## Redundant Brake Pedal Micro Switch, Removal VN-2 VHD-2 VT

### SP 432-026, Redundant Brake Pedal Micro Switch, Removal

(August 2008)

W8003940

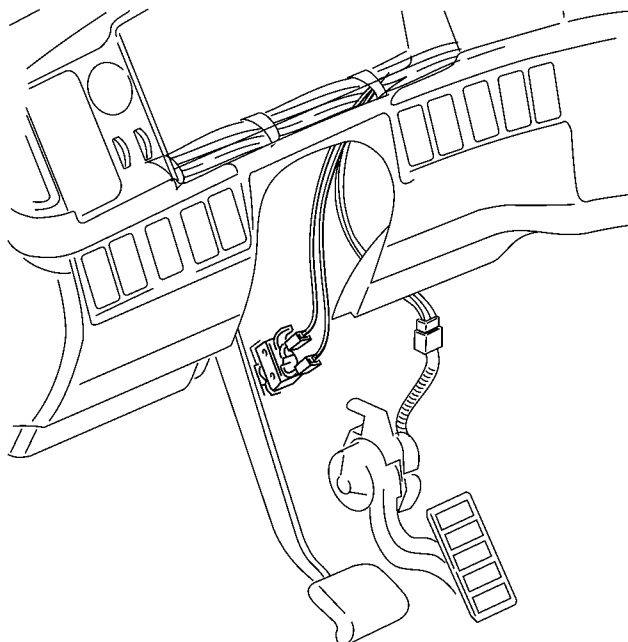
- 1 Remove the drivers side lower right hand dash panel to gain access to the brake pedal switch.

W3007823

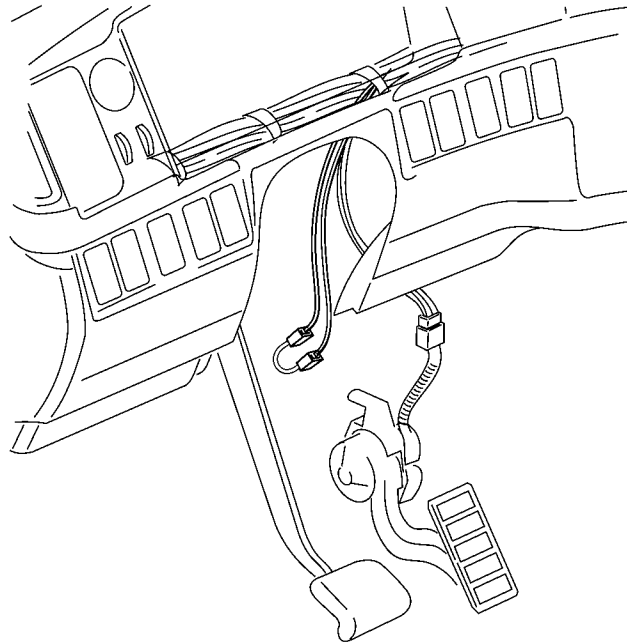
- 2 Locate and remove the I-Shift brake pedal micro switch.

- 3 Insert jumper wire (20913375) into the now vacant connector terminals.
